**REDEVELOPMENT OF HIDDEN FOREST**  
 A MIXED USE TOWN CENTER DEVELOPMENT  
**THE PACIFIC GROUP, INC.**  
 5155 DUNREE DRIVE  
 SUITE 150  
 ATLANTA, GEORGIA 30327  
 PHONE: 770-984-8170

**MASTER REZONING SITE PLAN**

**PETITION NO:** Z-26

SUBJECT: Z-26  
Town Center Associates, LLC  
R-20, NS to PVC  
Land Lot(s): 501, 502, 507, 508  
District: 16

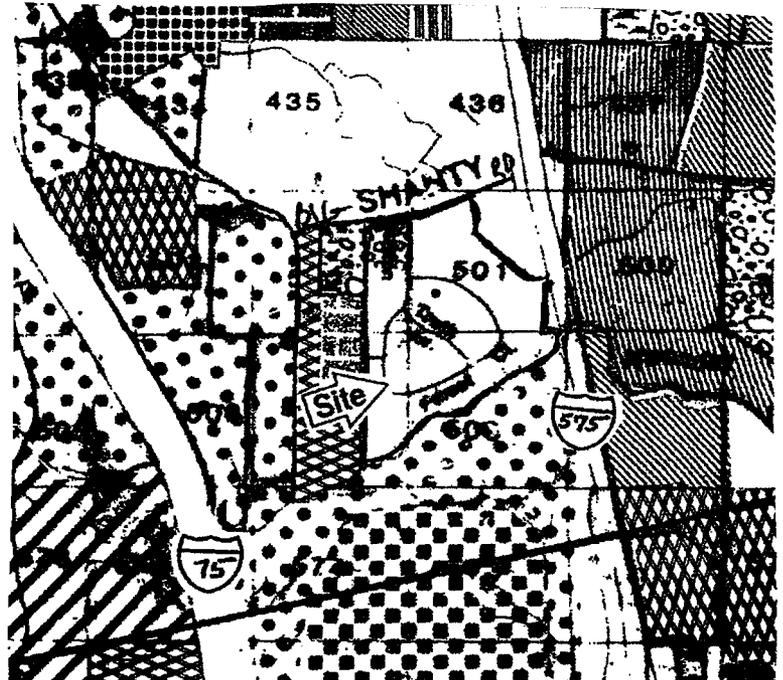
1. This site is located on Noonday Creek just upstream of the bridge at I-575 and is currently developed as a residential subdivision (Hidden Forest S/D) and a small community church. The site is impacted significantly by the floodplain of Noonday Creek to the south and an unnamed tributary to the east. The proposed bridge over Noonday Creek will require a CLOMR/LOMR from FEMA. The study will be required to be submitted to FEMA prior to permitting. A no-rise certification will also be required to verify that the bridge design will not result in any increase in upstream flood elevations.

2. A portion of the site is located downstream of a Category I Dam (Noonday Creek Structure #16). The dam breach zone from this dam must be determined and all proposed structures must be located outside this hazard area.

3. Several of the proposed buildings encroach within the regulatory floodplain. Cobb County Ordinances require that all structures be located outside the floodplain and that no net fill be placed to reduce the current floodplain storage. Volume compensation must be provided for any floodplain fill including the Town Center Connector Road embankment. Also, a portion of the site area is currently owned by the Cobb County Water System. At least one of these parcels was purchased using GEMA grant funds as part of flood mitigation program and has deed restrictions that preclude development. A revised site plan is needed to address all these issues and an agreement reached with CCWS regarding transfer of this property.

4. A buffer variance will be required for a portion of the site where Street F encroaches into the 50-foot stream buffer and 25-foot impervious setback limit. Without the variance a site plan modification will be needed.

Construct an auxiliary lane along the entire property frontage along Big Shanty Road to include a deceleration lane for the right-in only driveway near the western property line.

Separation of public and private right-of-ways will need to be defined with note explaining the division conditions.

The right-of-way for the Town Center Connector is not sufficient.

Corners of Block 1, 2, 3, 4 adjacent to the Town Center / Big Shanty connector shall have distinctive architectural detailing.

East end of Parking Deck 1 & 3 shall have aesthetically pleasing facades.

West end of Parking Deck 2 & 4 shall have aesthetically pleasing facades.
